DEPARTMENT OF LICENSING AND REGULATORY AFFAIRS

CONSTRUCTION CODE

PART 10a. MICHIGAN ENERGY CODE

**FIGURE C301.1a
CLIMATE ZONES**

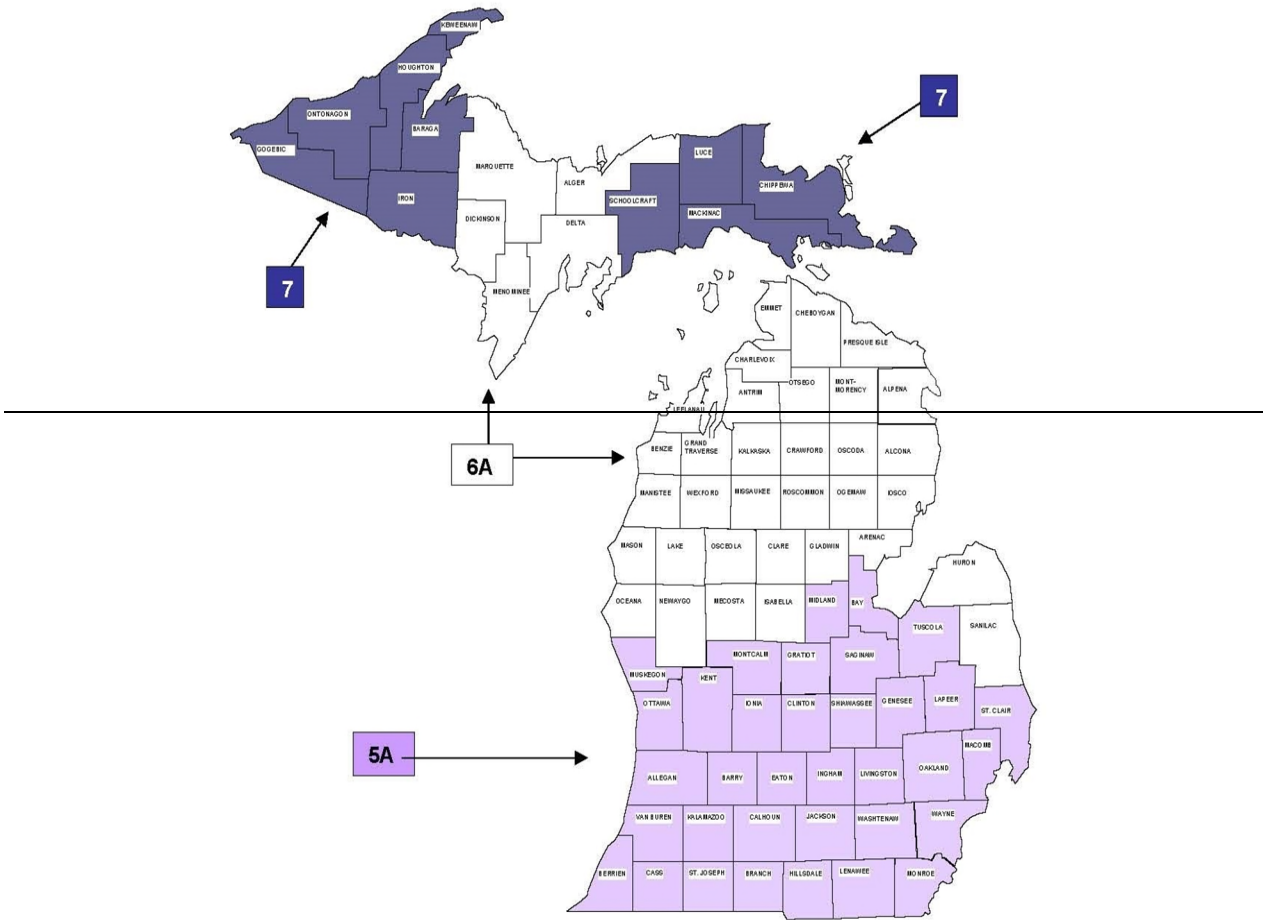
R 408.31096 Climate zones. Rescinded.

~~Rule 1096. Sections C301.1, Tables C301.1 and C301.3(2) of the code are amended and Figure C301.1a is added to the code to read as follows:~~

~~C301.1. General. Climate zones from figures C301.1, C301.1a, or table C301.1 shall be used to determine the applicable requirements of this code.~~
